City of Marco Island

Re: Addendum #1 ITB 2025-015

South Water Treatment Plant Odor Control Rehabilitation

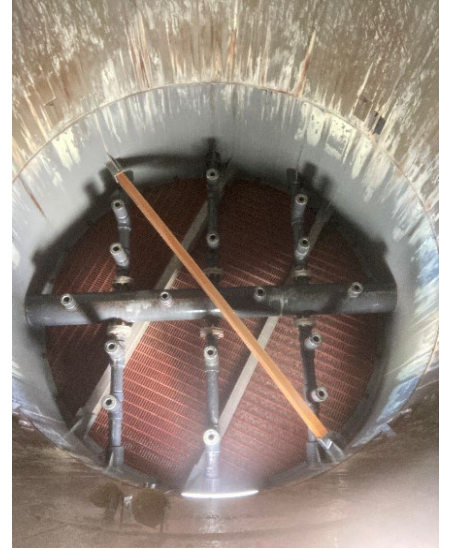
1. **Could you please clarify what 'blower outfall to be replaced on Scrubber A' refers to in this context?** Correction: the outflow blower pipe must be replaced on Degasser B not A. It should be installed horizontally, without a 90% bend. The picture below shows the outflow pipe with a bend, which is incorrect.

SWTP Degasifier A - Pictures of the interior after the collapsed (2024)

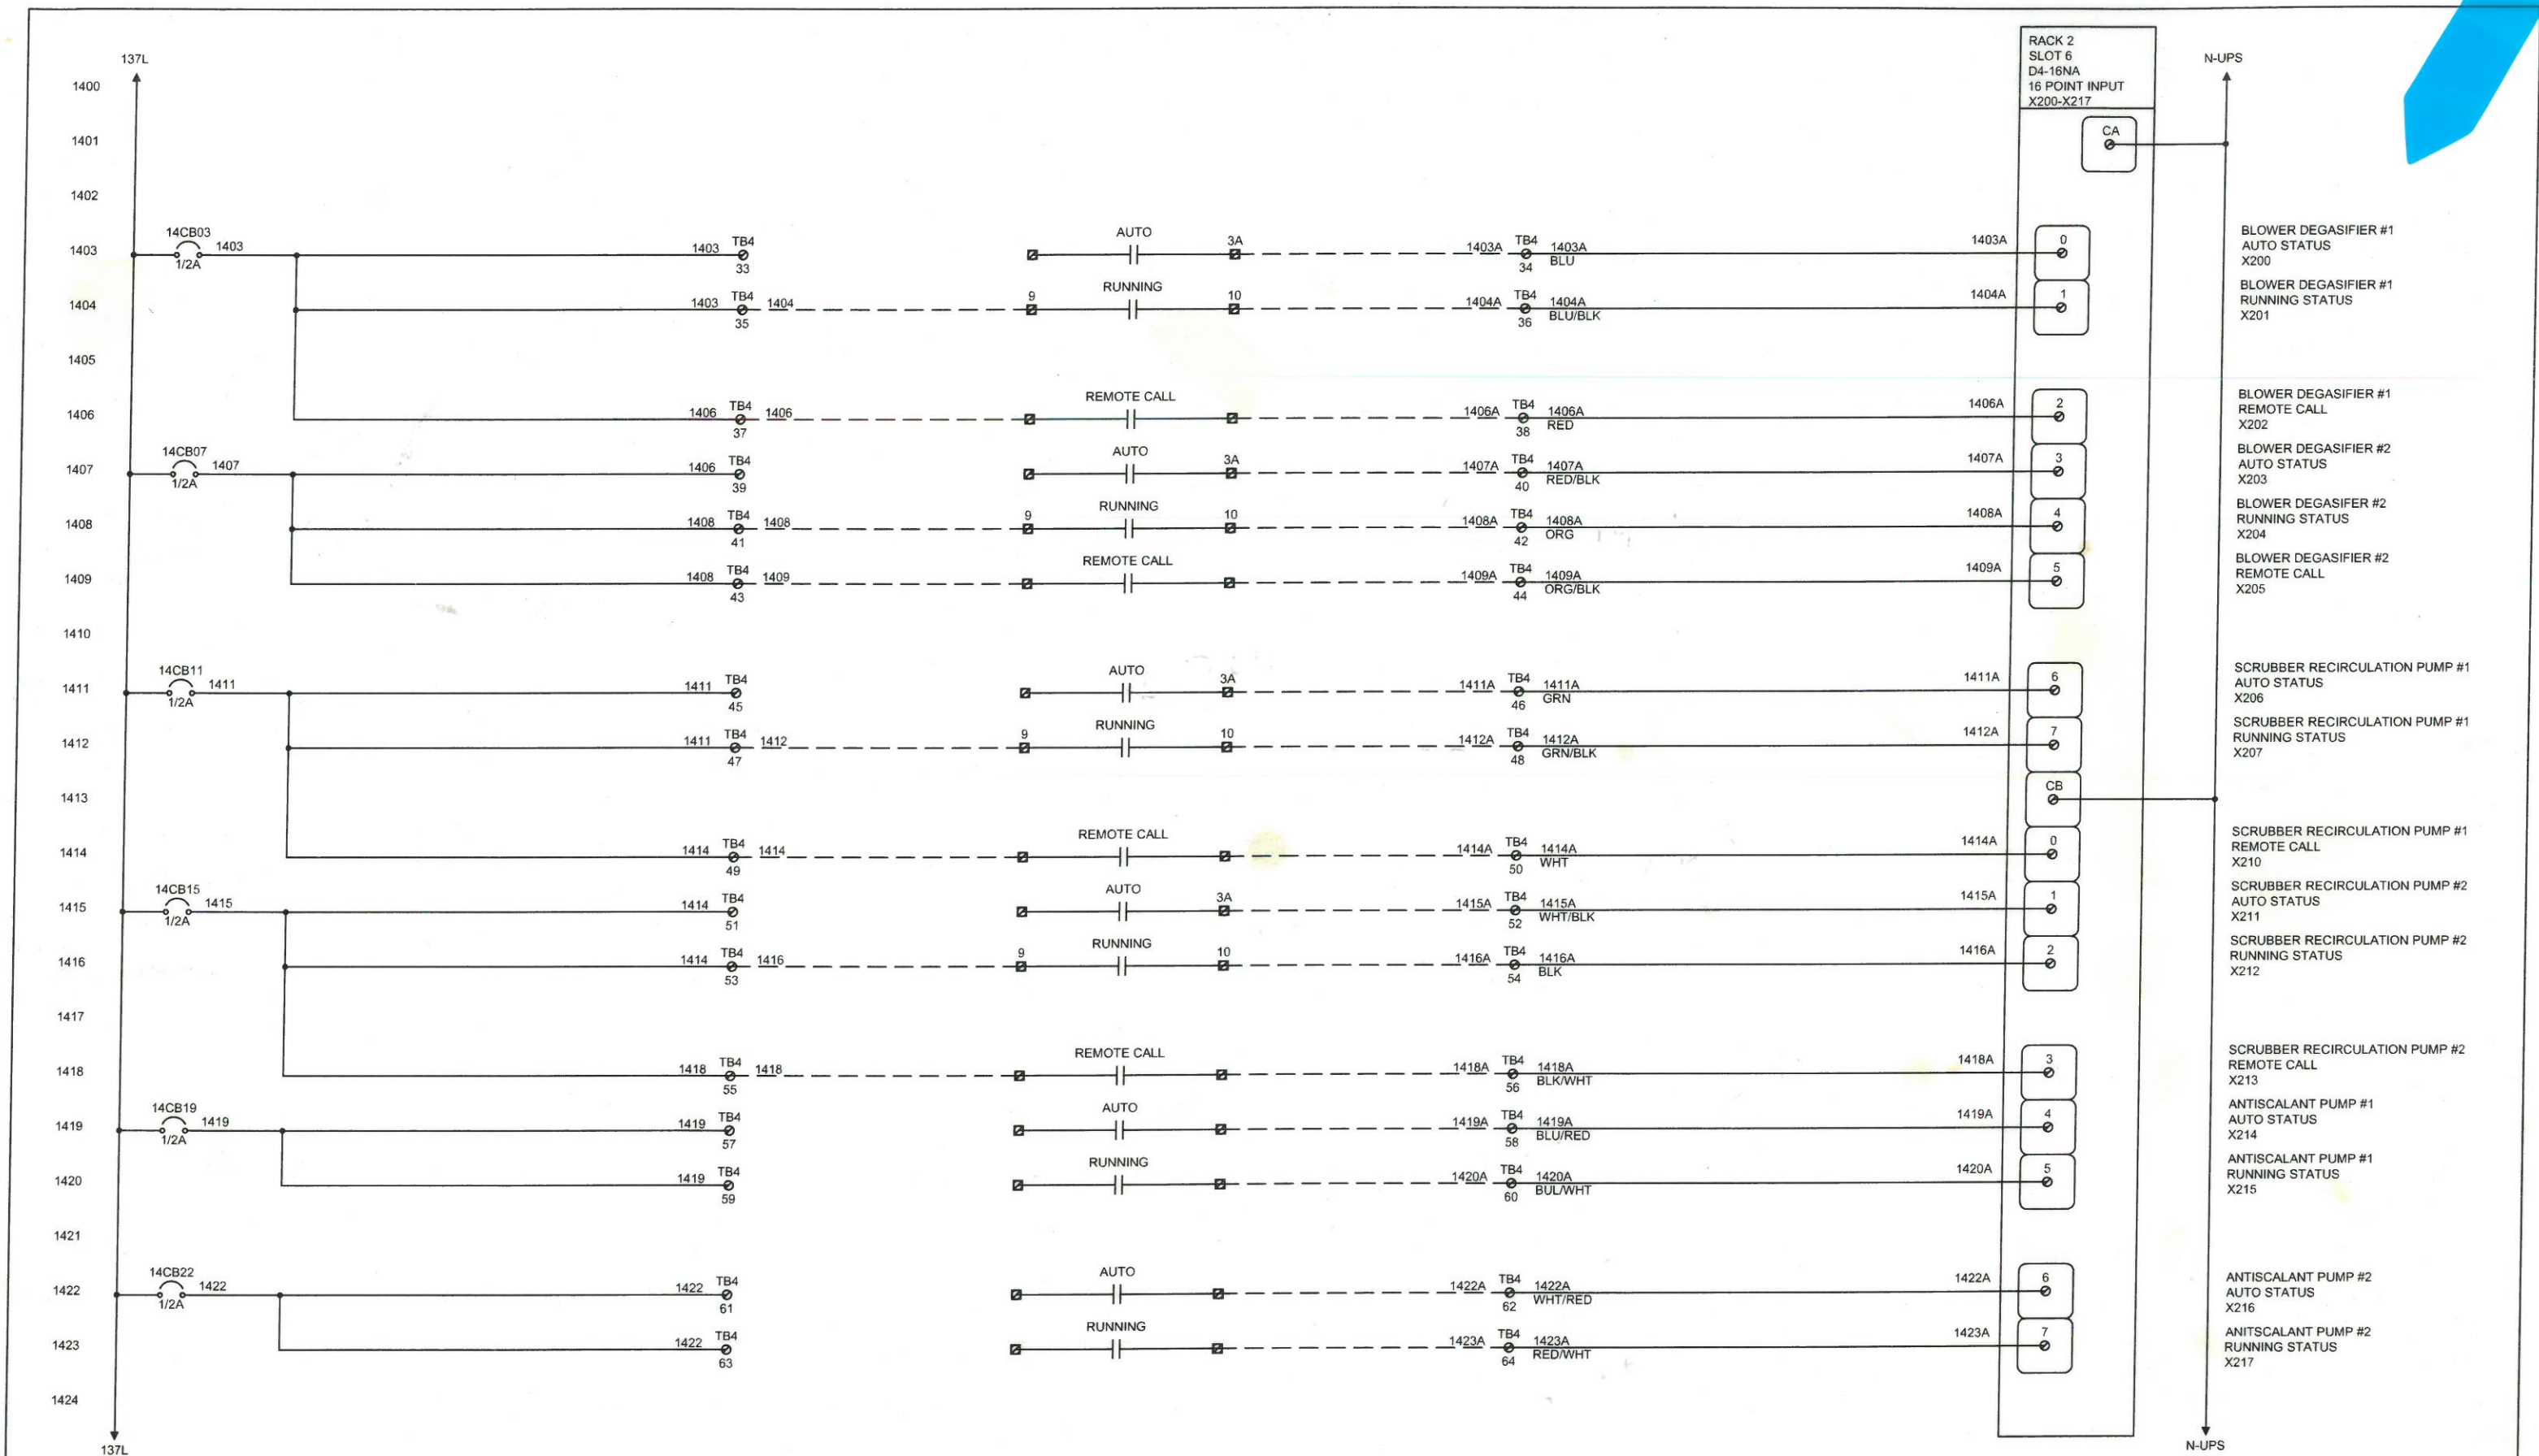
2. **Do you have any pictures of the interior of the degasifier both prior to and following the repair?** Yes, the City has pictures from the interior of Degasifier A taken when the media collapsed in 2024. The pictures show the support, grading, and beams that were damaged. See attached pictures in the document.
3. **Please provide the control schematic/logic for all control panels to be replaced.** A picture of the control panels is shown below, and the control logic plans are attached to this document.
